# Access Compliance Report

## Public Rights-of-Way

### (Curb Ramps)

Intersection ID: 19799	Main Street: SHARON_RD	Cross Street: COLONY_RD	Location: S
ADA ID: 306F3F50B559	Ramp Type: PerpDiag	Initial Pass/Fail: Fail	Overall Compliance: No
			Severity Score: 13.75

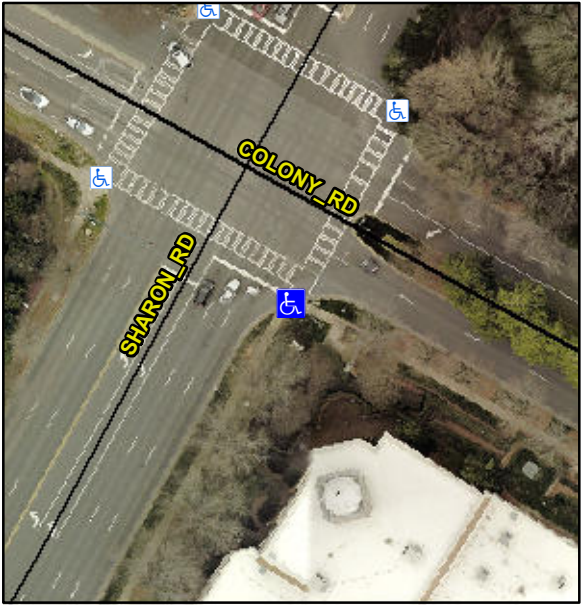
Codes/Mitigation Info/Possible Solution			Field Measurements/Component Compliance		
	Possible Solutions:		<b>Compliance</b>	<b>Description</b>	<b>Data</b>
	<b>Remove &amp; Replace Curb Ramp With Two New Directional Ramps or Equivalent. Restripe Crosswalk.</b>		N/A	Ramp Length (in)	60.0
			Yes	Ramp Width (in)	50.0
			N/A	Flare Type LT	N/A
			N/A	Flare Slope LT (%)	N/A
			N/A	Flare Traversable LT?	N/A
			N/A	Landing Length (in)	N/A
			N/A	Landing Width (in)	N/A
			N/A	Landing Slope (%)	N/A
			N/A	Landing X Slope (%)	N/A
<p>Surveyor Notes:</p> <p><b>N/A</b></p> <p>PROW/ADA:</p> <p><b>Not Found, R304.2.2, R304.5.3</b></p>			N/A	Flare Type RT	N/A
			N/A	Flare Slope RT (%)	N/A
			N/A	Flare Traversable RT?	N/A
			N/A	DWS Provided?	N/A
			N/A	DWS Contrast?	N/A
			N/A	DWS Length (in)	N/A
			N/A	DWS Full Width?	N/A
			N/A	DWS Offset (in)	N/A
			N/A	Shared Landing?	N/A
			N/A	Gutter Ponding?	N/A
			N/A	Gutter Lip Ht (in)	N/A

N/A	Painted X Walk1?	Yes
				X Walk 1 Direction	To NE
			N/A	X Walk 1 Width (in)	108.0
				X Walk 1 Slope (%)	0.2
				X Walk 1 X Slope (%)	2.0
			N/A	Ramp inside XWalk1?	Yes
				Road Slope (%)	1.9
				Road X Slope (%)	2.8
			N/A	Any Obstructions?	N/A
				Obstruction Type	
Total Cost:		\$ 3400.00			
			N/A		N/A
			Yes	Surface Condition? (G/P)	Good
